# UNITED STATES PATENT AND TRADEMARK OFFICE

APPLICATION NO.	FILING DATE	FIRST NAMED INVENTOR	ATTORNEY DOCKET NO.	CONFIRMATION NO.
10/596,982	09/01/2006	Rainer Mueller	A8472PCT-UT	3866
43749 7590 01/15/2009 CHRISTOPHER PARADIES, PH.D. FOWLER WHITE BOGGS BANKER, P.A. 501 E KENNEDY BLVD, STE. 1900 TAMPA, FL 33602				
EXAMINER GREEN, RICHARD R				
ART UNIT		PAPER NUMBER		
3644				
MAIL DATE		DELIVERY MODE		
01/15/2009		PAPER

### Office Action Summary

## **DETAILED ACTION**

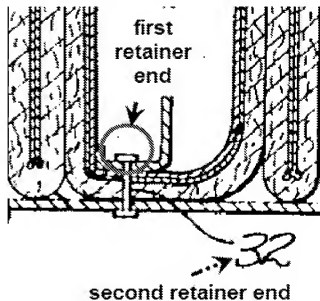
a “burn-through-proof” attachment element having first and second retainer ends at opposing ends (fig. 1, particularly enlargement above: first retainer end is the fastener circled and labeled, second retainer end is the spacer 32 – the attachment element is the combination of the two pieces and is considered to be “burn-through-proof” in the same way that waterproof watches are only waterproof to a certain depth and fireproof materials are only fireproof to a certain temperature and duration of exposure to

temperature) and being disposed through the hole in the rib attachment region such that a retainer end is located on either of opposing sides of the rib attachment region (fig. 1: element 32 is arranged on an opposing side of the rib from the side on which the displayed fastener is arranged) and the first retainer end attaches the first end of one insulation package and the second end of another insulation package to the rib attachment region through holes located in both ends such that the ends overlap (fig. 1, at and around element 32 and in light of col. 4, lines 4-7), and one of the insulation packages in the attached pair is retained on the opposite side of the rib attachment region by passing the second retainer end through a hole formed in the other insulation package of the attached pair (fig. 1, at and around element 32, in light of col. 4, lines 4-7: as the sides of the rib attachment region were initially introduced, "the opposite side" is the same side of the rib attachment region that the second retainer end is located which is opposite the side that the first retainer end is located, and in fig. 1 one of the attached pair of insulation packages is retained on the same side of the rib attachment region as the second retainer end 32 by the element 32 which passes through corresponding holes in both the first end of one insulation package and the second end of the other insulation package; it appears that three holes are required here, and the third may be considered to be the hole through layer 10 of the first end on one insulation package, wherein the first hole is in the first end and would be the hole through layer 16 of the same insulation package, and the second hole is through layer 16 of the second end of the other insulation package);

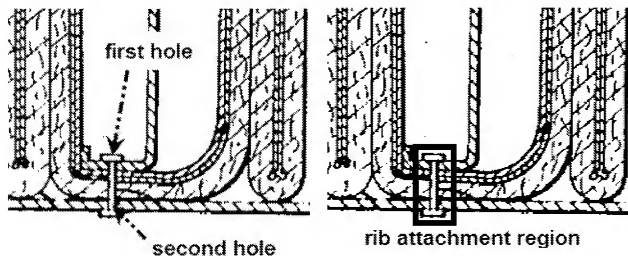
stringers for stiffening panels of an outer skin of the fuselage (figs. 1 and 2, stringers at 22 are capable of stiffening outer skin panels 23) and ribs arranged perpendicular to the longitudinal axis of the aircraft at a specified distance (figs. 1 and 2, ribs at 20 are a distance apart), where the ribs are attached to the stringers at one end (figs. 1 and 2, as where left numeral 20 points in fig. 1) and unattached at another end, culminating in an integrated rib carrier (fig. 2: rib 20 ends in a 90 degree bend, which is a rib carrier), and the ribs further having a rib attachment region located below a longitudinal side of each of the ribs adjacent the attachment region (fig. 2, the flat inside edge of the ribs 20 is an attachment region which at the top of the aircraft is below a longitudinal side of the ribs);

wherein a hole is drilled through the rib attachment region (fig. 1, element 32 is received through a hole drilled in the topmost portion of rib 20, which is located between the lip shown to the left of element 32 and the attached end shown touching the stringer

22), a first hole is formed in a package region of each of the two insulation packages and a second hole is formed in the flat end section of each of the two insulation packages, wherein the first and second holes are retained on opposite sides of the rib attachment region by the "burn-through-proof" attachment element (fig. 1, particularly above enlargement – in fig. 1 this arrangement occurs twice and so a similar arrangement as follows is considered for the other side of the middle insulation package 17 – the first hole is formed in the insulation package through layer 16 on the side of the package closest the skin of the airplane and the second hole is formed in the insulation package through layer 10 on the side of the package closest the interior of the fuselage; the rib attachment region being considered the three dimensional region where the package is attached to the rib – as in the enlargement of fig. 1 above – whereby the first hole and the second hole are retained on opposite sides of the rib attachment region by the attachment element).
